THE CITY OF DURHAM TRUST

DM/21/02360/FPA: Sniperley Park

Our third submission expands on the transport-related policies and provides detailed commentary demonstrating the failure to comply with NPPF and County Plan policies.

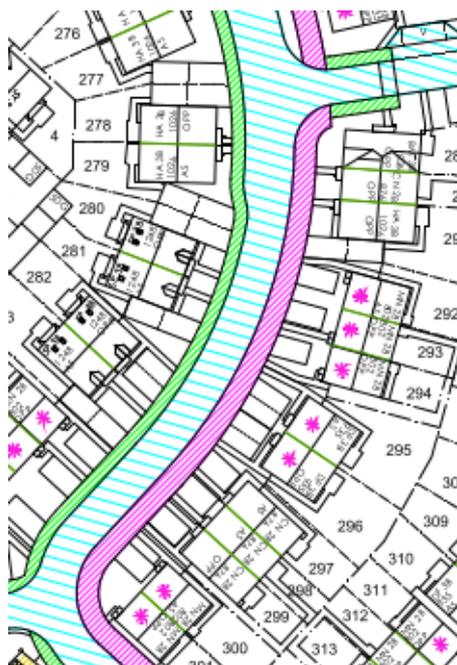
Another example: a path passing between two areas of housing (starting in the middle at the bottom of the excerpt and proceeding north-east), without links to the ends of the roads on either side:

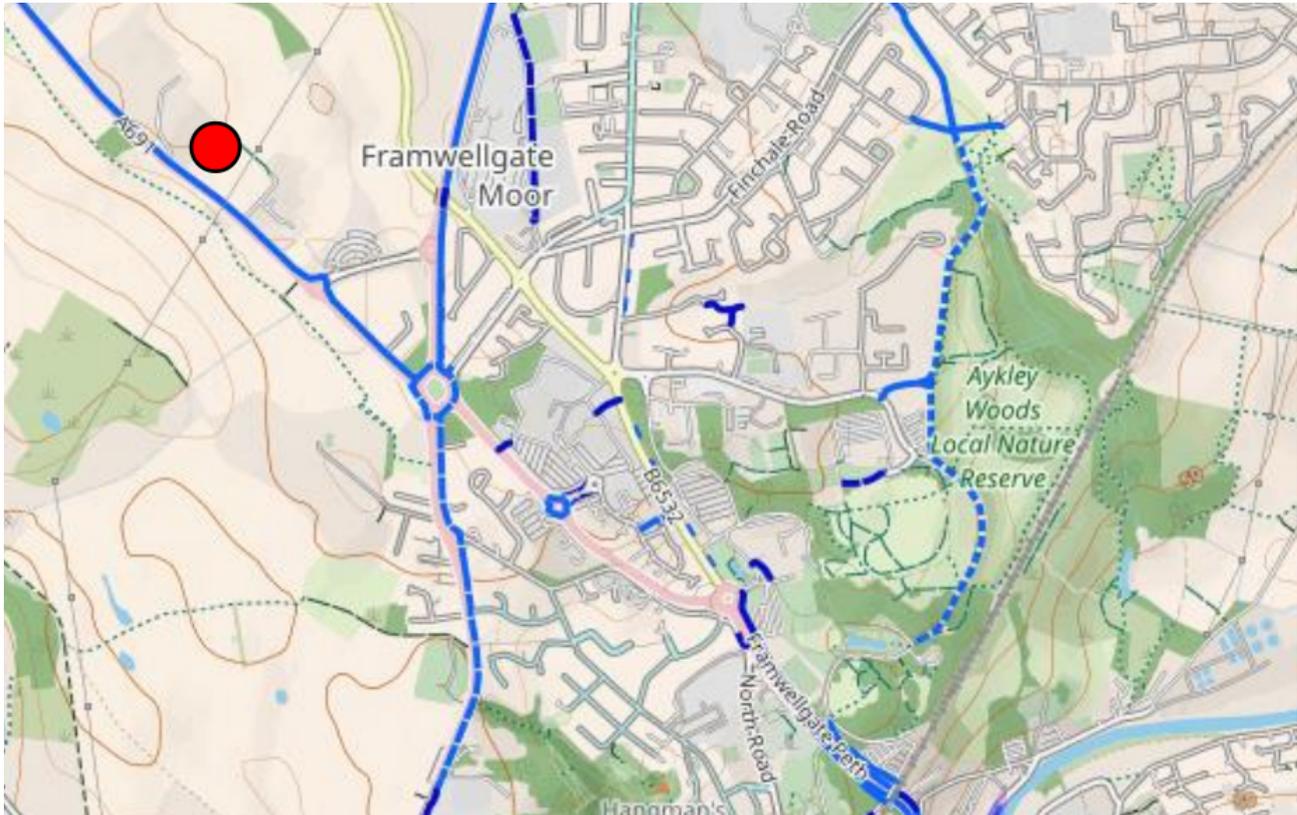
If you apply the LTN 1/20 junction assessment tool to the junctions in the area, and to the new roundabout junction proposed for access to the site from the A691, all of the potential cycle movements that cross arms of the roundabouts would achieve a score of zero. CD195 Designing for Cycling Traffic, which is part of the Design Manual for Roads and Bridges, requires grade separation or signal-controlled crossings where cycle routes cross high flow 40mph roads or 2-lane roundabout entries within a 30mph limit.
